SUBJECT: COMANCHE PEAK NUCLEAR POWER PLANT, UNITS 3 AND 4
DOCKET NUMBERS 52-034 AND 52-035
RESPONSE TO REQUEST FOR ADDITIONAL INFORMATION NO. 3183

Attachment 1. Response to Request for Additional Information No. 3183 (CP RAI #88)

SRP SECTION: 13.03 - Emergency Planning

Add Figures K-1 through K-16 as pages K-2 through K-17

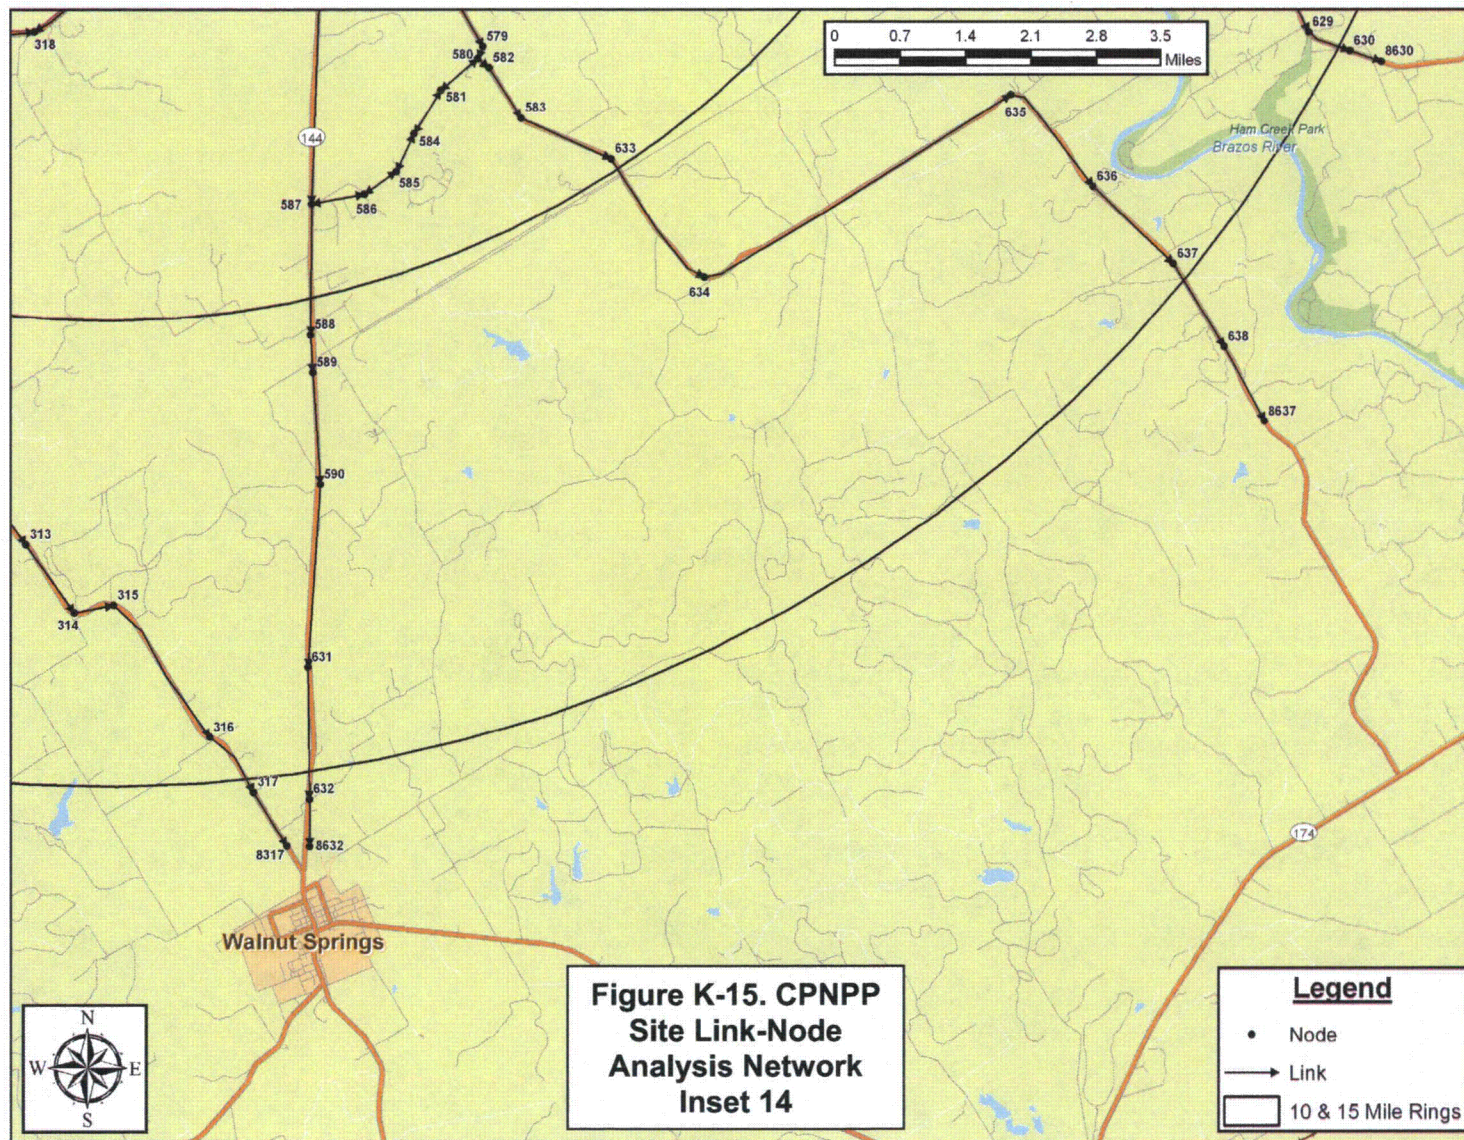
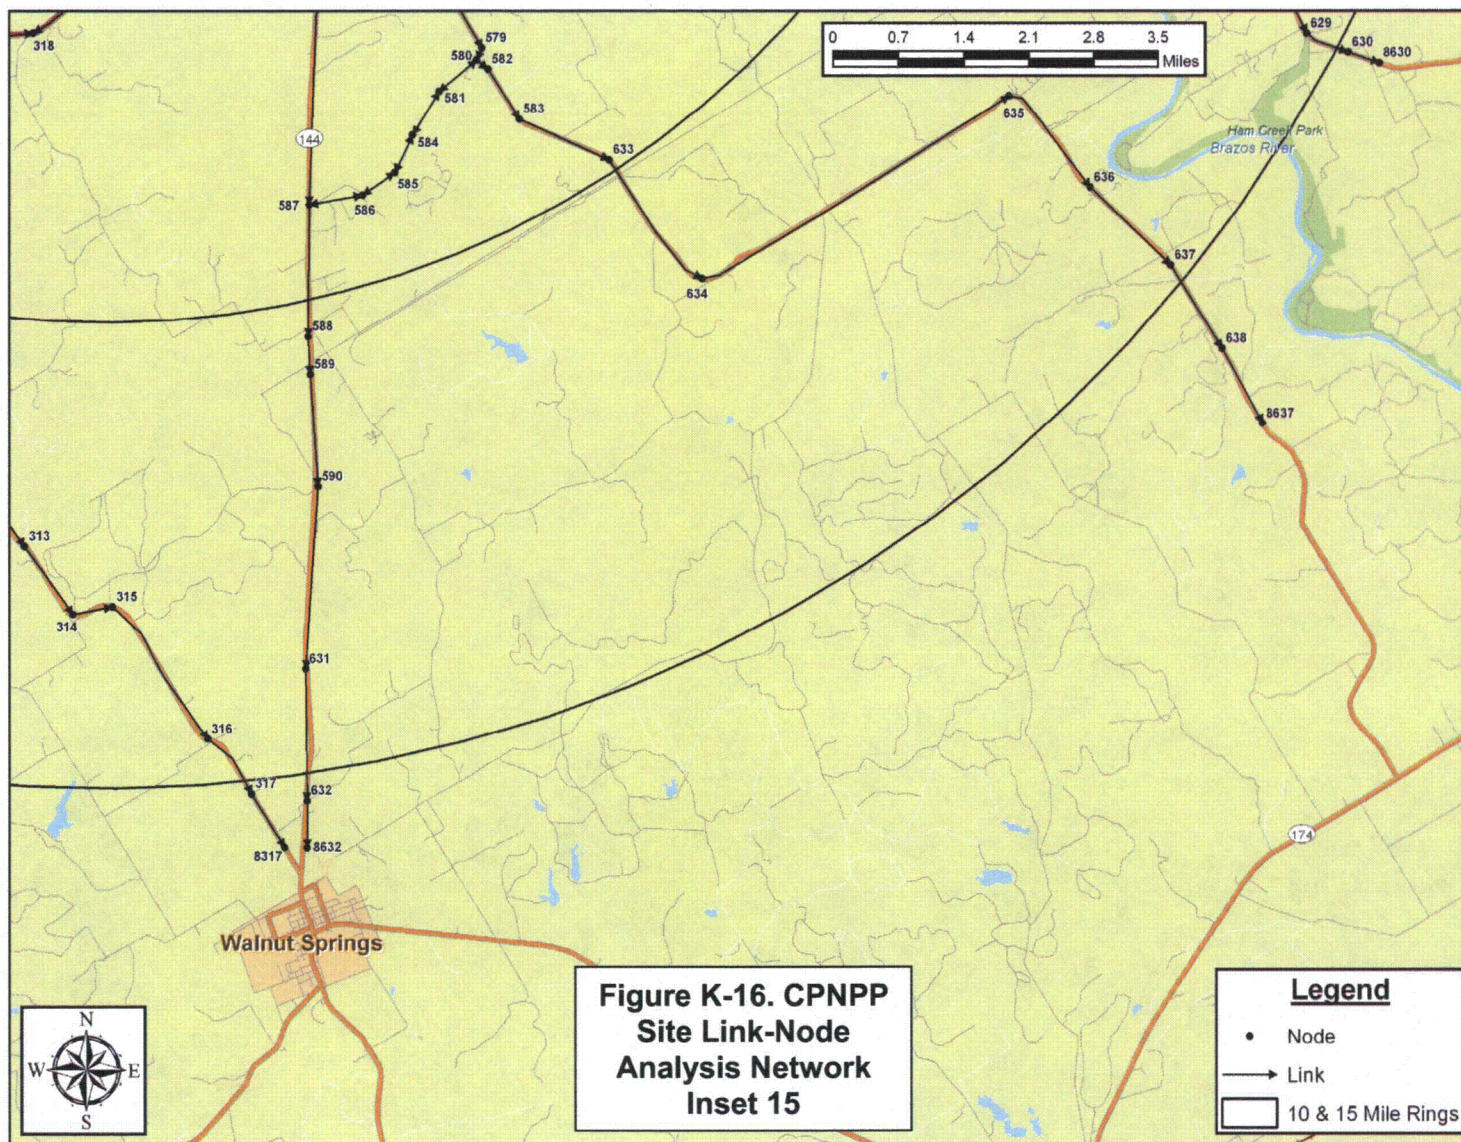
- B. Due to the scale of Figure 1-2, the node labels and link directional arrows were illegible and were not included with the original report. Figure 1-2 has been divided into several figures and will be included in Appendix K in a future revision of the ETE report. These figures show the directional arrows and annotate the nodes within the link-node analysis network. Appendix K will be renamed "Evacuation Roadway Network", the Table of Contents will be revised to reflect the new title of Appendix K and the table in Appendix K will be numbered Table K-1 and titled, "Evacuation Roadway Network Characteristics." The reference to Figure 1-2 in Section 1.3 will also be revised to reference the newly added figures in Appendix K.

Figure 1-2 presents the link-node analysis network that was constructed to model the evacuation roadway network in the EPZ and Shadow Region. The detailed figures provided in Appendix K depict the analysis network with directional arrows shown and node numbers provided. The observations made during the field survey were used to calibrate the analysis network.

Figure 5-1. Events and Activities Preceding the Evacuation Trip

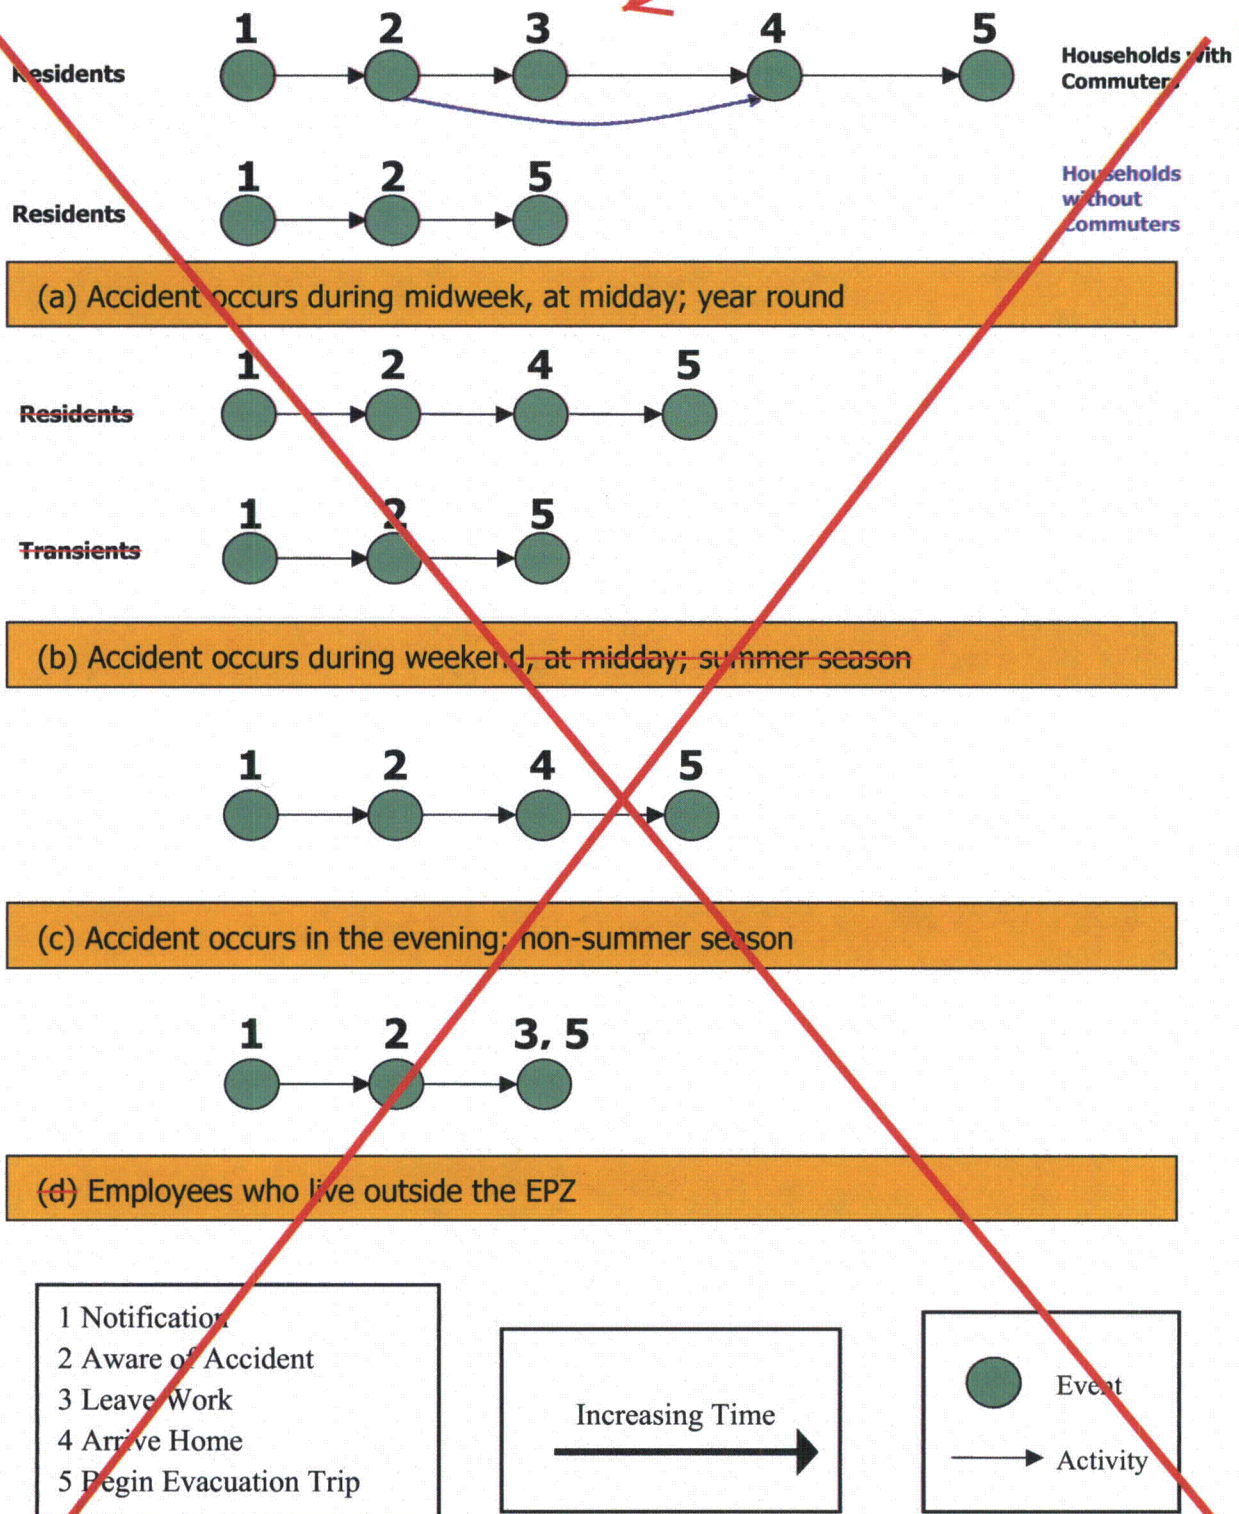
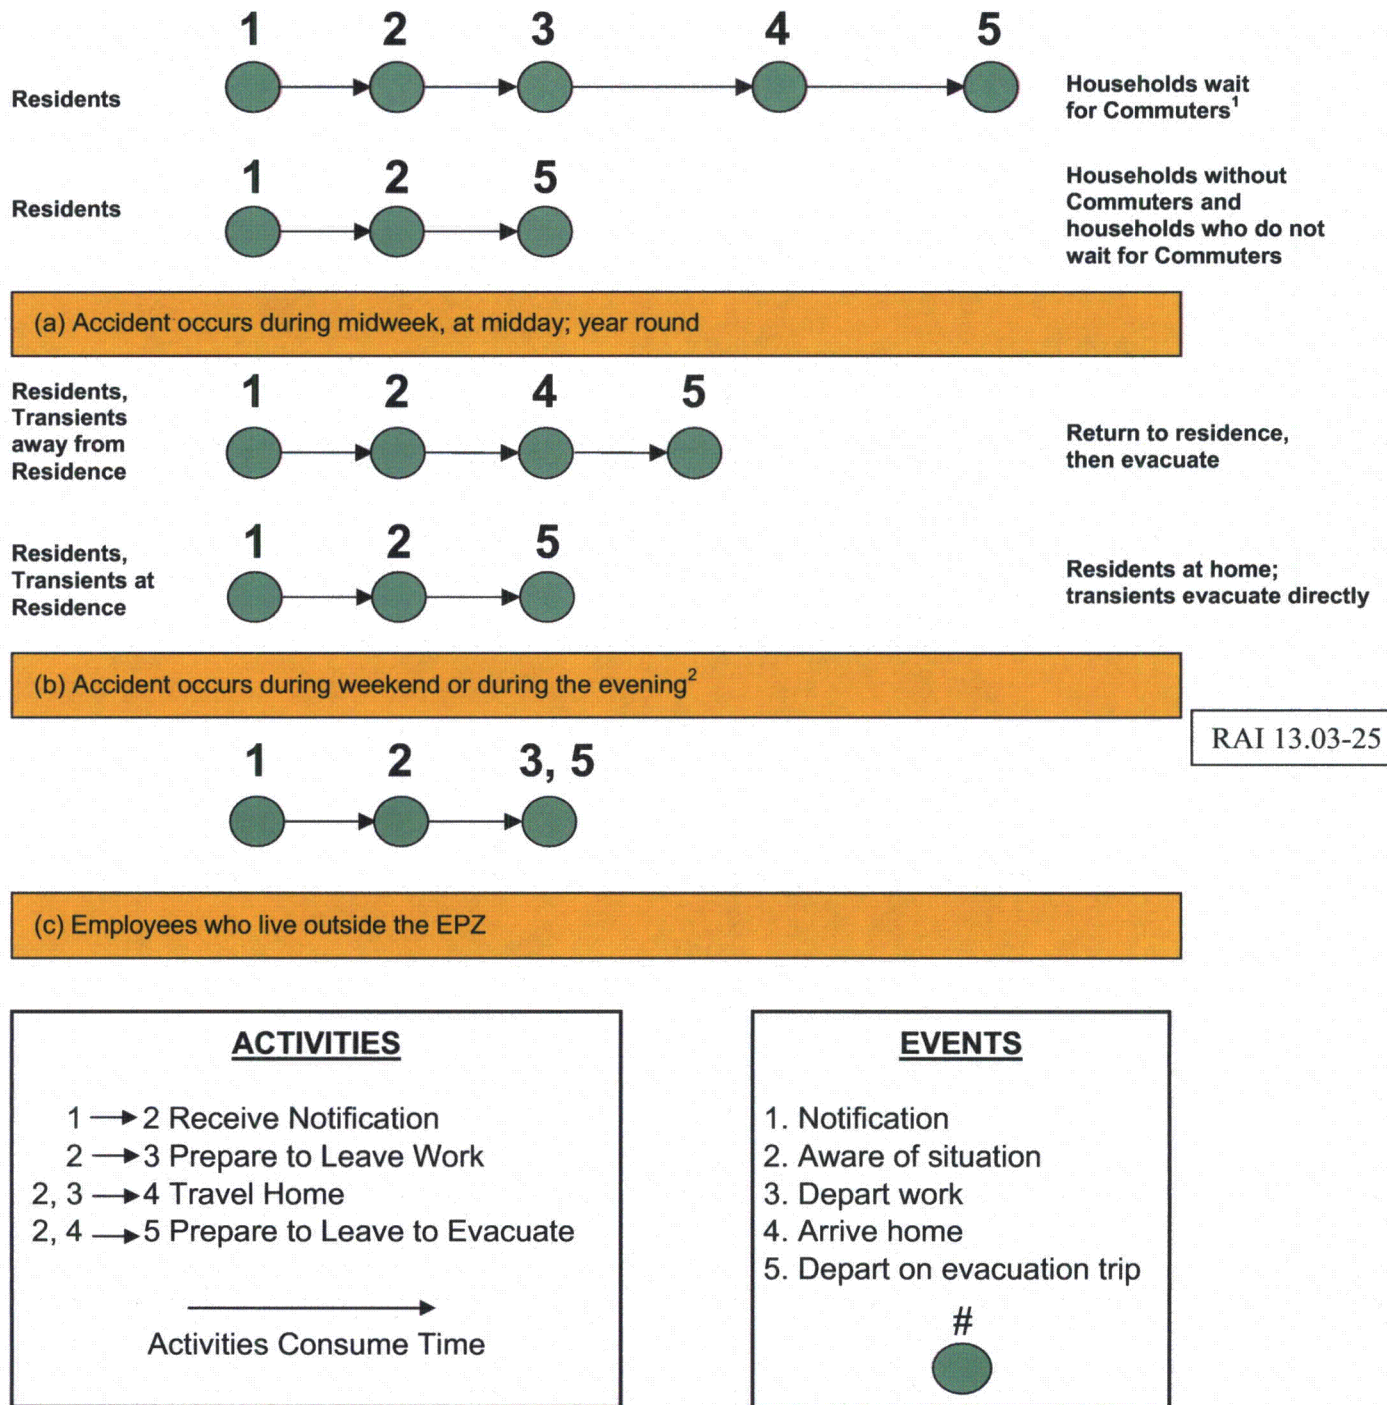
- B. In Figure 5-1, "Events and Activities Preceding the Evacuation Trip," the timeline for households with commuters includes time to return home, if needed, and then evacuate. The timeline for households without commuters indicates these residents are at home. Members of households without commuters may not be at home when they become aware of the accident and may need to return home.

- 1. Explain why the events and activities timeline for households without commuters as represented in Figure 5-1 is different from the timeline for households with commuters.

- 2. Discuss any effect this may have on the ETE calculation. Revise the ETE report as needed.
- C. The timeline for transients, also in Figure 5-1, indicates that transients do not return home, (e.g., hotel) prior to evacuating.

- 1. Discuss why Figure 5-1, indicates transients do not return to their residence (e.g., hotel) prior to evacuation.
 - 2. Discuss any effect this may have on the time for the transient population to evacuate, if they do return to their hotel prior to leaving. Revise the ETE report as needed.

To clarify these assumptions, Figure 5-1 will be updated to address the possibility that transients may return to lodging facilities or campsites prior to beginning their evacuation trip. The text of Section 5 will be revised to correspond with the changes to Figure 5-1.
